Access Compliance Report

Public Rights-of-Way

Intersection ID: 50445	Main Street: ELIZABETH MADISON CT	Cross Street: ALICE MCGINN DR	Location: SW
ADA ID: 7C2462BF335F	Ramp Type: BlendTrans1	Initial Pass/Fail: Pass	Overall Compliance: No
Codes/Mitigation Info/Possible Solution		Field Measurements/Component Compliance	
Severity Score: 5

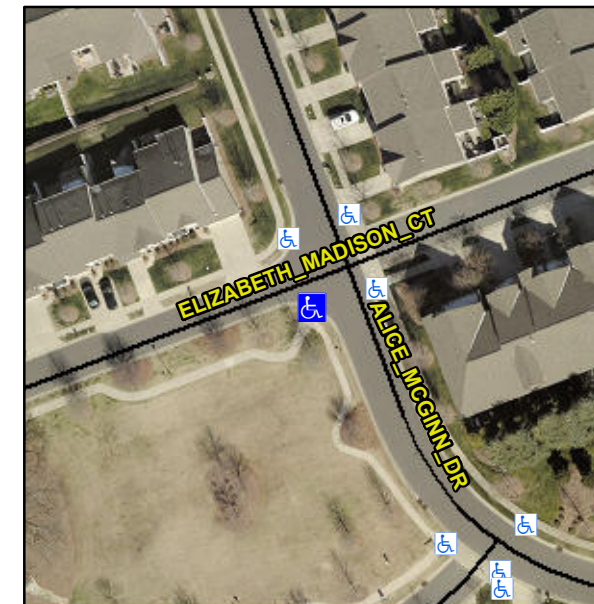
Not Found, R304.2.2-Perp, R304.3.2-Para, R305.2, R304.5.4

Compliance	Description	Data	Compliance	Description	Data
N/A	Ramp Length (in)	48.0	Yes	BlendTrans Slope (%)	4.2
Yes	Ramp Width (in)	48.0	Yes	BlendTrans XSlope (%)	1.8
N/A	Flare Type LT	None	N/A	Flare Type RT	None
N/A	Flare Slope LT (%)	N/A	N/A	Flare Slope RT (%)	N/A
N/A	Flare Traversable LT?	N/A	N/A	Flare Traversable RT?	N/A
Yes	Landing Length (in)	48.0	Yes	DWS Provided?	Yes
Yes	Landing Width (in)	48.0	Yes	DWS Contrast?	Yes
No	Landing Slope (%)	2.1	Yes	DWS Length (in)	24.0
Yes	Landing X Slope (%)	1.7	Yes	DWS Full Width?	Yes
N/A	Landing Curb? (Y/N)	No	No	DWS Offset (in)	2.3
N/A	Shared Landing?	No			
Yes	Gutter Ponding?	No	No	Gutter Slope (%)	9.3
Yes	Gutter Lip Ht (in)	0.0	Yes	Gutter X Slope (%)	1.5
N/A	Painted X Walk1?	No	N/A	Painted X Walk2?	No
	X Walk 1 Direction	To E		X Walk 2 Direction	To N
	X Walk 1 Width (in)	N/A		X Walk 2 Width (in)	N/A
	X Walk 1 Slope (%)	0.5		X Walk 2 Slope (%)	0.8
	X Walk 1 X Slope (%)	2.0		X Walk 2 X Slope (%)	0.0

N/A	Ramp inside XWalk1?	N/A	N/A	Ramp inside XWalk2?	N/A
	Road Slope (%)	1.1		Clear Space?	Yes
	Road X Slope (%)	2.0	N/A	Clear Space to XWalk (in)	N/A
Yes	Any Obstructions?	No	Yes	Storm Grate/Utility Hazard?	No
	Obstruction Type			Storm Grate/Utility Type	
		N/A			N/A
			Yes	Surface Condition? (G/P)	Good
			No	Curb Slope (%)	7.0

Remove & Replace Curb Ramp With Two New Directional Ramps or Equivalent. Remove & Replace Gutter.
